Office Action Summary	Application No. 10/586,079	Applicant(s) TILLMANN, HORST	
	Examiner EMILY M. MORGAN	Art Unit 3677

DETAILED ACTION

Claims 11-20 are rejected under 35 U.S.C. 103(a) as being unpatentable over patent 6317922 to Kondratuk.

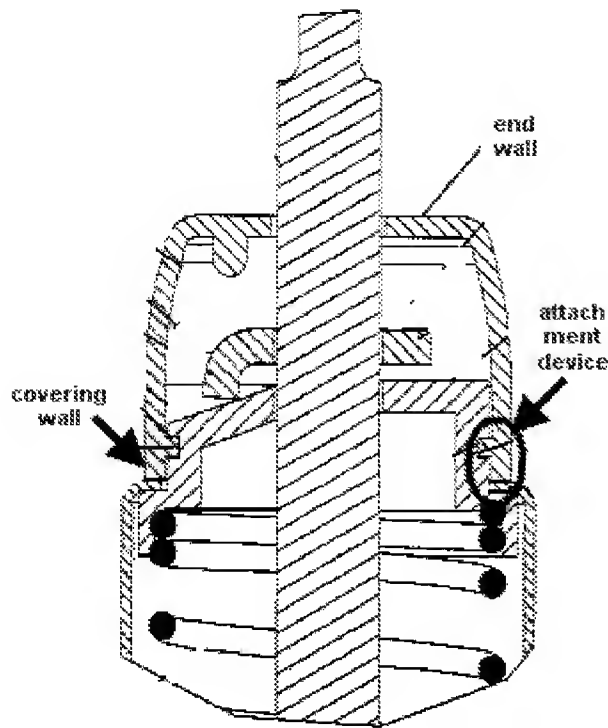
Regarding claim 11, Kondratuk discloses an end cover 40 for a housing of a door closer (figure 10), comprising: a cover housing 40 comprising: an end wall; two opposite convexly curved lateral walls coupled to each other by the end wall; and a flat covering wall connected to the end wall and the lateral walls; and an attachment device supported by the cover housing. Please see figure below.

Kondratuk discloses the claimed invention except for the contour of the end wall and making the side walls flat formed into the shape of the door closer. It would have been obvious to one having ordinary skill in the art at the time the invention as made to shape the cap into a matching shape of the article, a change in the shape of a prior art device is a design consideration within the skill of the art. *In re Dailey*, 357 F.2d 669, 149 USPQ 47 (CCPA 1966). Kondratuk discloses a door closer, with a similar end cap for the cover of a door closer. The end wall is not shown as being convexly curved, and the side walls are convexly curved into a round shape. The shape of the cover and its side walls match the shape of the door closer, which is cylindrical. Changing the shape of the sidewalls to match the shape of the closer would have been obvious to one of ordinary skill in the art, as would the change of the shape of the end wall. The function

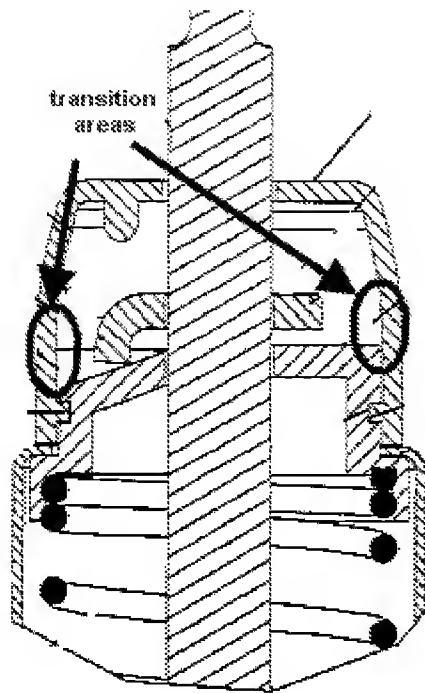
Regarding claim 12, Kondratuk discloses the end cover of claim 11, wherein the attachment device is an insert connection. The inner piece of the closer must be inserted into the opening of the cover in order for the cover to properly attach to the closer (figure 11).

Regarding claims 13 and 14, Kondratuk discloses the end cover of claim 12, wherein the insert connection is an insert flange projecting into an inner chamber defined by the cover housing. Cover 40 integrally forms flange 52 (figure 11), which projects inwardly into the space created by the cap. Since the flange forms inwardly from the cap, it projects into the inner chamber.

Regarding claim 15, Kondratuk discloses the end cover of claim 13, wherein the end wall has a central area, the insert flange being integrally connected to the central area of the end wall. Figure 11 of Kondratuk also discloses having a knob on the interior of the end wall 40, which can be considered an insert flange integrally connected to the end wall.

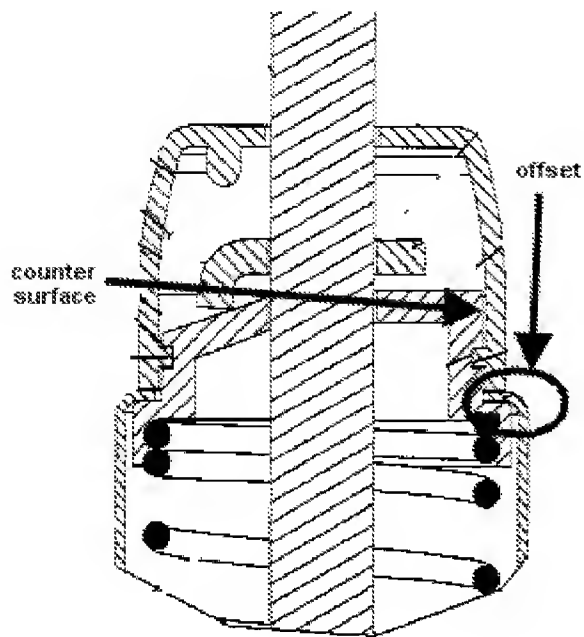
Regarding claim 19, examiner notes this claim integrates a door closer with two of the inventor's covers (of claim 1) on each end of the door closer. Kondratuk discloses a door closer, with one end having the cover as claimed by applicant. The difference between the claim and claim 19 is the claim recites: two end covers. It would have been obvious to one of ordinary skill in the art at the time the invention was made to apply an end cover to both ends, since it has been held that mere duplication of the essential working parts of a device involves only routine skilled the art. *St. Regis Paper Co. v. Bemis Co.*, 193 USPQ 8. This would aid the article in becoming a more aesthetically pleasing door closer, and would perform similarly.

Regarding claim 20, Kondratuk discloses the door closer of claim 19, wherein each of the end sides as shown having a diminished transition area for receiving the respective end cover, the diminished transition area having a counter-surface (shown below) covered by the covering wall of the respective end cover, and creating an offset in an outer contour of the main housing.
